MIDLAND - PERMANENT DEWATERING

Subject: Summary of CFCO Response to NRC Questions 24, 45 & 47 on permanent dewatering relative to geotechnical engineering issues.

SUBJECT: Report on Review of Geotechnical Aspects of the Seismic Safety
of Midland Nuclear Power Plant

SUBJECT: Visit to Midland Michigan NPP on 27-28 February 1980, A Review of the Midland Plant Units 1 and 2 FSAR (Including Revisions 1-27)

Fig 47-2

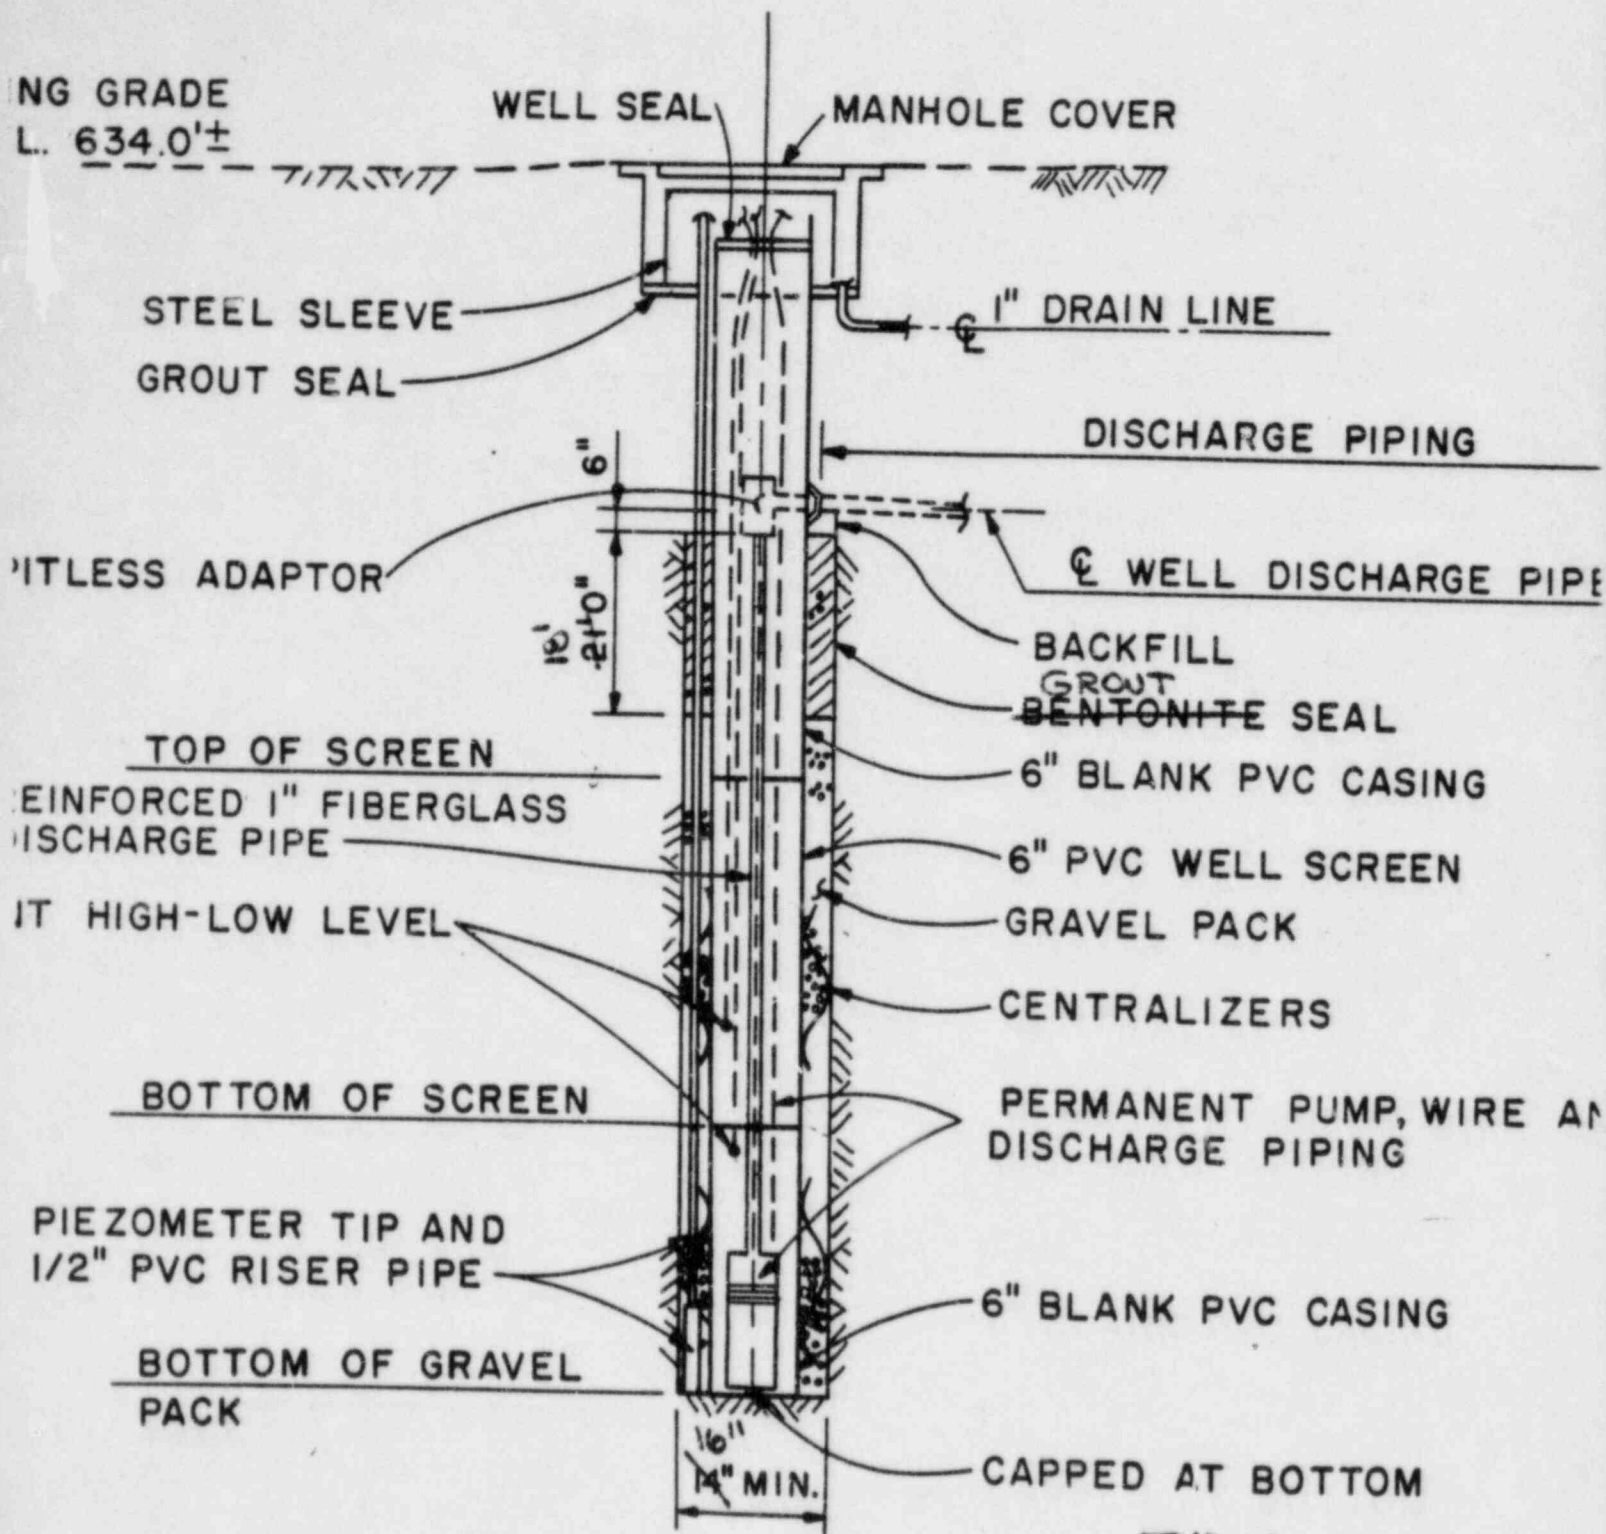
TYPICAL
PERMANENT DEWATERING
WELL

Figure 47-1

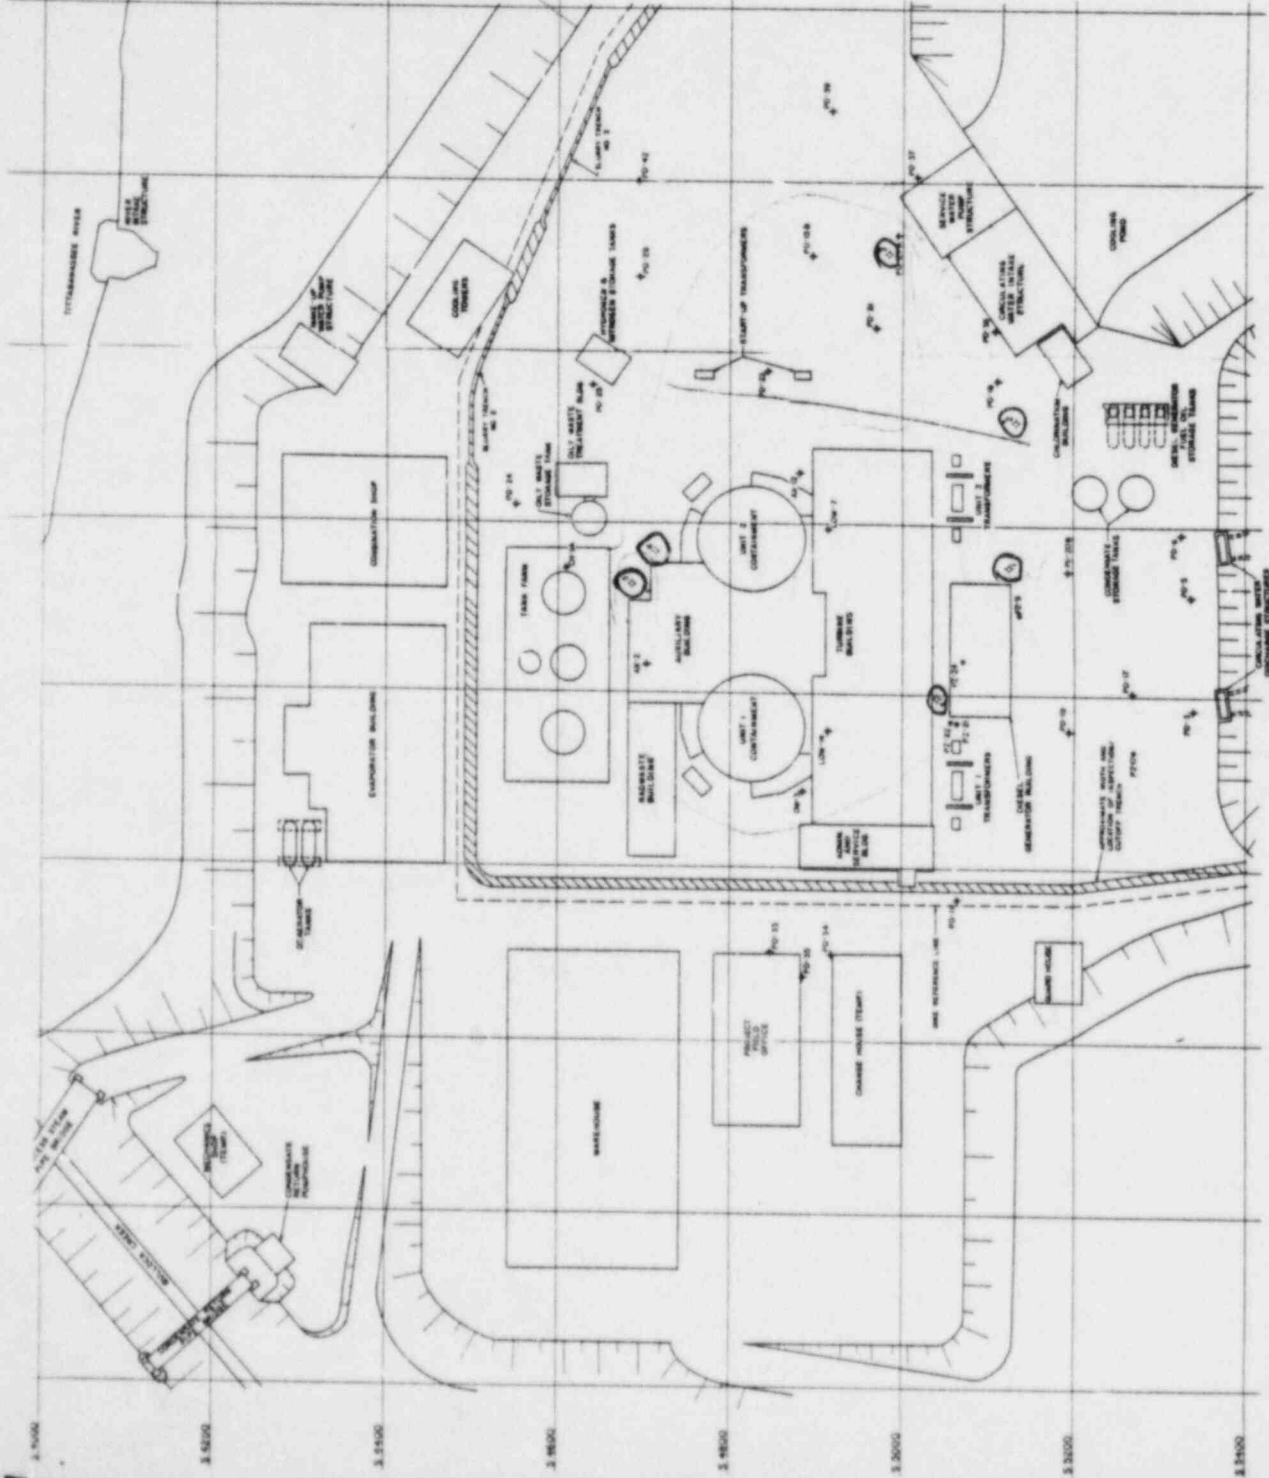
Where are observation wells located that will be used to monitor GWT during plant life? (See Fig. 47-1 which in addition to showing location of observation wells also shows permanent piezometers & monitoring wells)

SHOWS LOCATIONS OF
PLANNED PERMANENT
MONITORING (Obs wells,
piezometers & monitoring
wells)

Fig 47-11 Rev.10

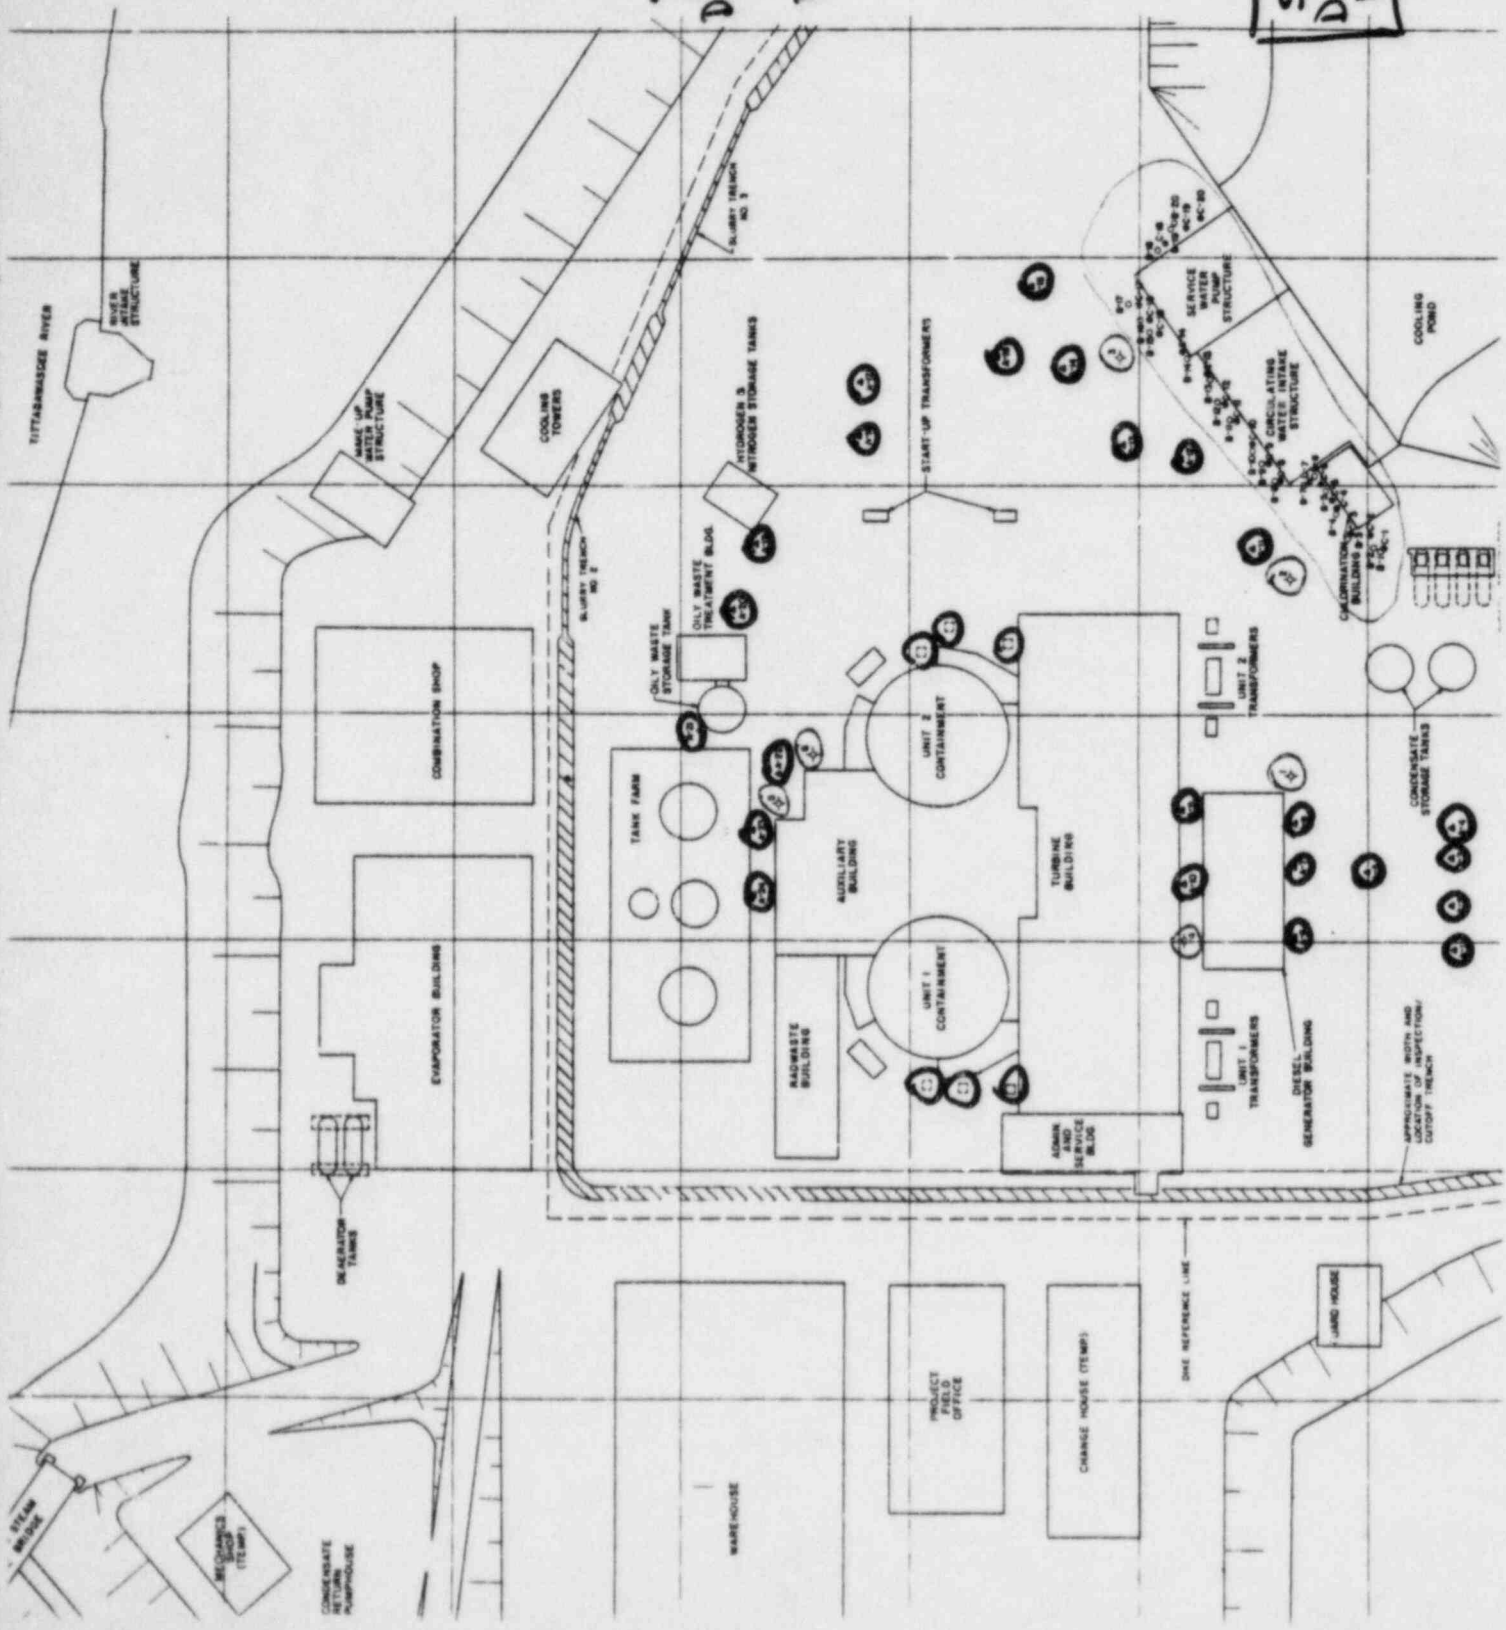
There are six wells for permanent monitoring (See Fig. 47-11). Two are near DGB, Two are near SW Structure & Chlorination Bldg, and Two are near Auxiliary Bldg (Railroad Bay end). ^{The six} Perm. monitoring wells can be converted to dewatering wells, if need were to arise.

Permanent Monitoring WELLS (6)

SHOWS PERMANENT DEWATERING WELL LOCATIONS

FIGURE BLOW COUNT VS ELEVATION
FOR STD. PENETRATION TESTS IN
SANDY SOILS IN THE PLANT
FILL AREA

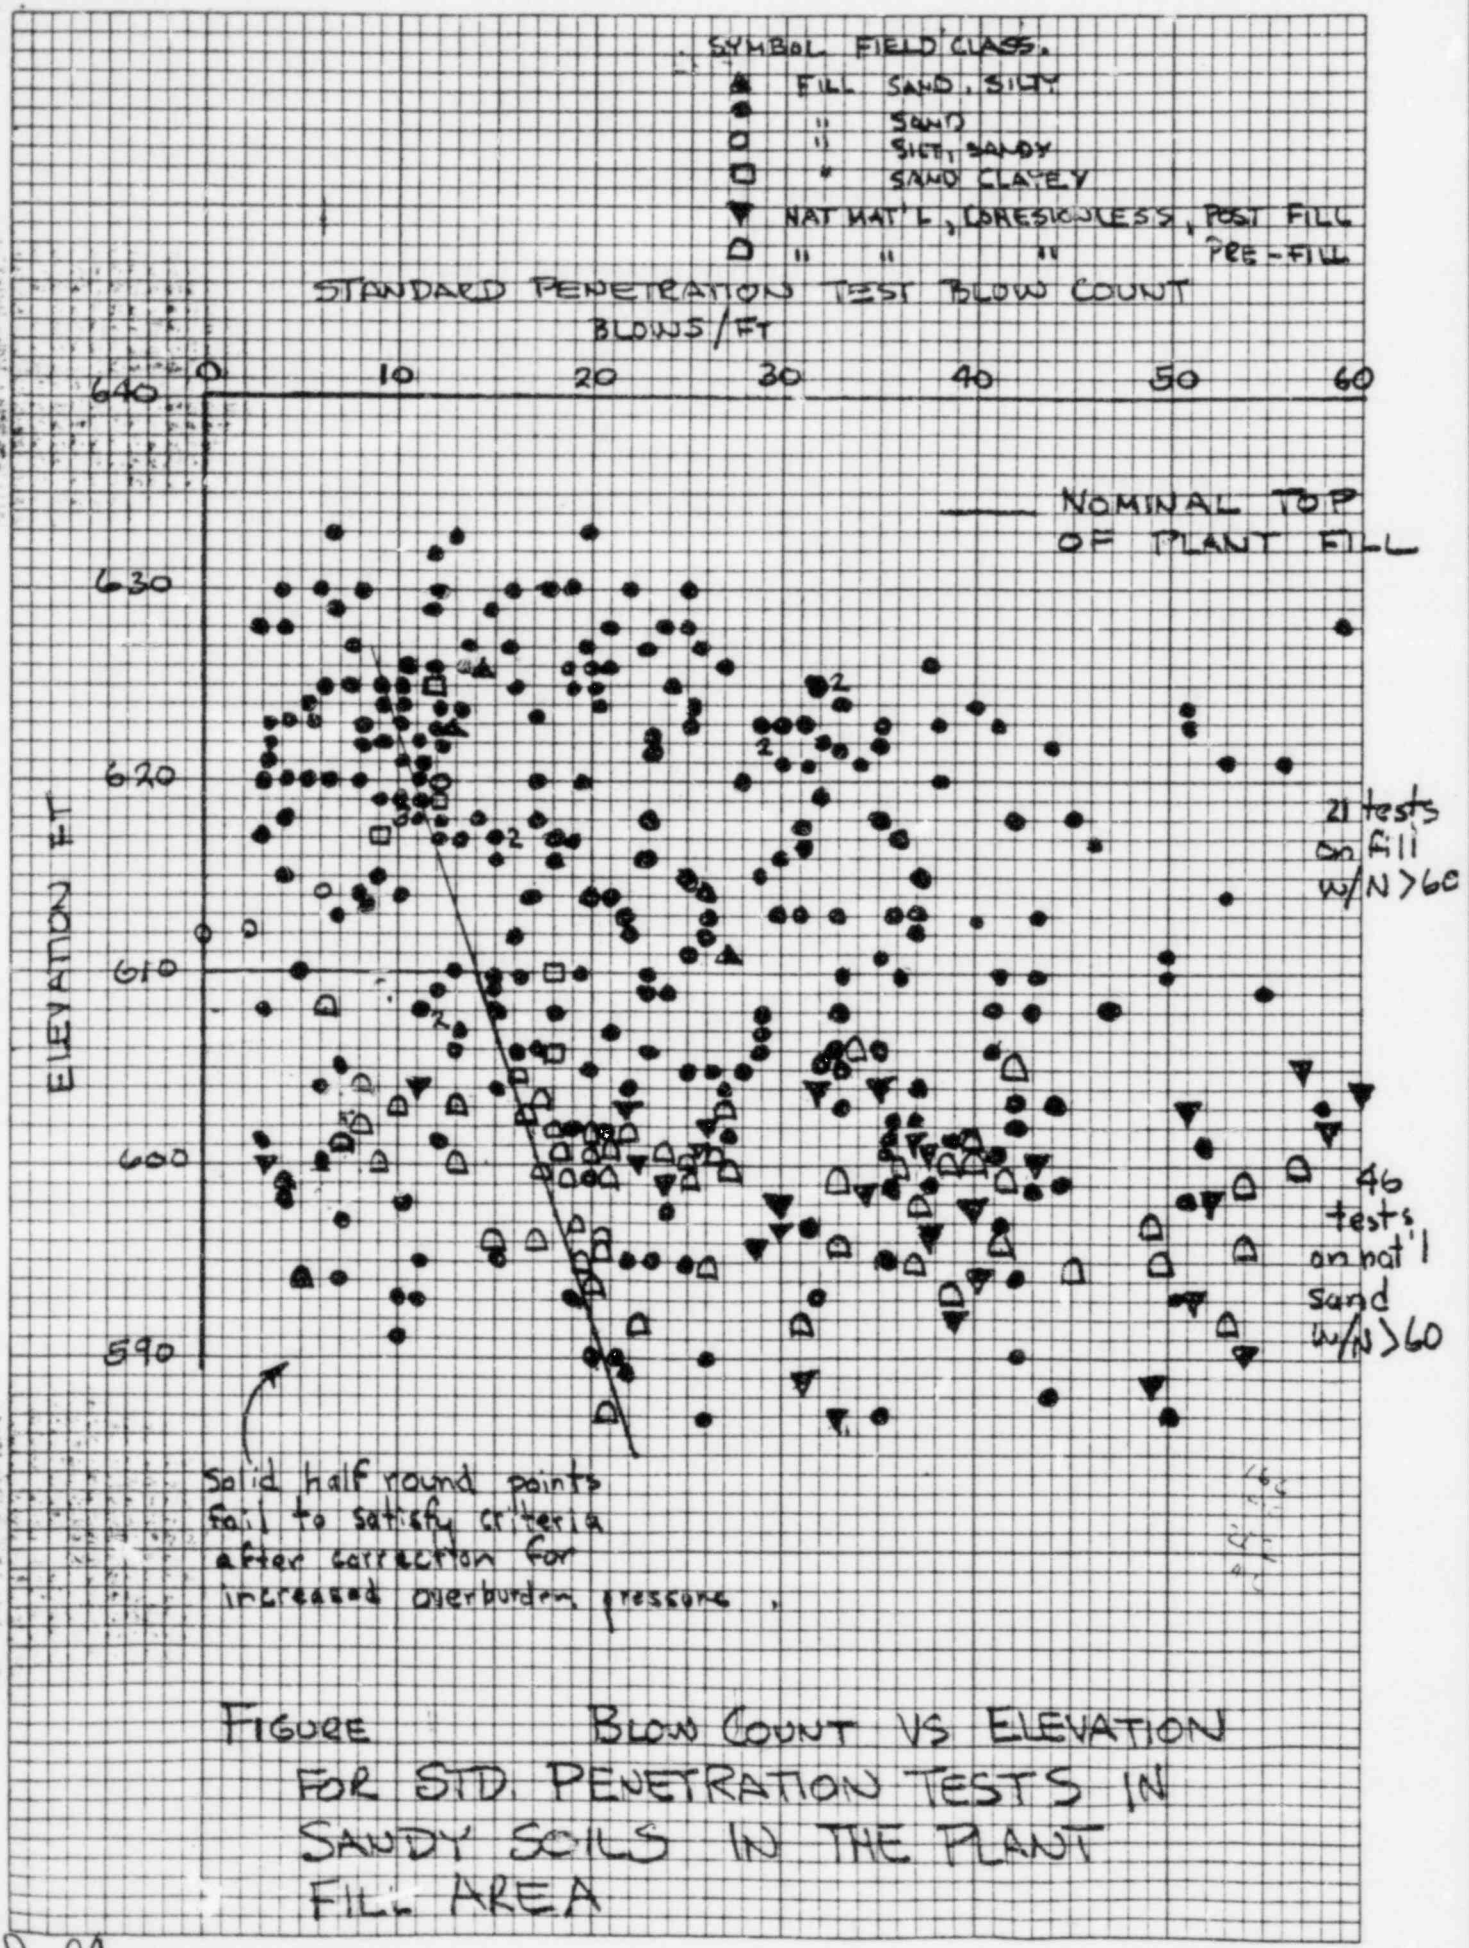
4. An independent Seed-Idriss Simplified Analysis was performed for the fill area under the assumption that the groundwater table was at or below elevation 610. For 0.19 g peak ground surface acceleration, it was found that blow counts as follows were required for a factor of safety of 1.5:

See End. 3 curve & calculations how determined

5. All of the plotted boring logs of the plant fill area furnished to me by the Detroit District, CE, were reviewed. Out of over 250 standard penetration tests on cohesionless plant fill or natural foundation material below elevation 610 which are shown in Incl 4, the criteria given above are not satisfied in four tests on natural materials located below the plant fill and in 23 tests located in the plant fill. These tests are listed in Incl 5. Some of the tests on natural material (N in the table) were conducted at depths of at less than 10 ft before approximately 35 ft of fill was placed over the location. Those tests are identified by the symbol B and prior to comparison with the criteria should be multiplied by a factor of about 2.3 to account for the increase in effective overburden pressure that results from the placement and future dewatering of the fill.
